# Product/Process Change Notice (PCN)

PCN\_WE\_CMBNiZn\_744841\_20150403\_Spacer.doc

Product Affected: WE-CMBNiZn Size XS Series

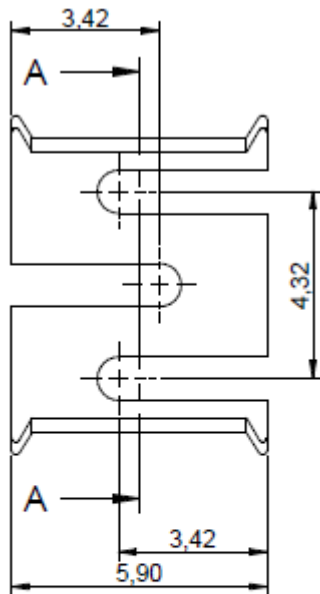
The plastic raw material has been changed from FR4 to Ultramid A3X2G5. The new spacer is mechanical fixed by the design therefore no additional glue joint is needed. We also increased the spacer thickness from 2,5 mm to 3,0 mm. Electrical and mechanical specifications will not be affected. Further the new spacer material is RoHS, REACH compliant and free of Halogen.
